Actual Situation of Lead Free Soldering for GMC

October 26th, 2007

All following GMC capacitors, with manufacturing code VO (October 2007) and later, are capable to fulfil the recommended reflow soldering profile for lead free process presented at end of this document.

Reflow soldering on the top body surface of the component

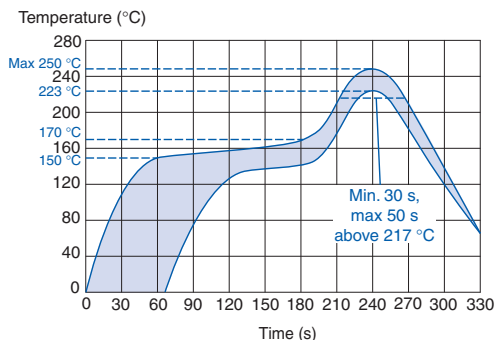
Preheating temperature should be less than 170 °C. The time above 217 °C should be less than 50 s. The peak temperature must not exceed 250 °C.

This profile is recommended for convection reflow ovens and IR reflow ovens. If vapour phase reflow oven is used, please consult Evox Rifa.

This recommended reflow soldering profile for lead free soldering is valid for those GMC products listed above, which have manufacturing code VO (October 2007) and later.
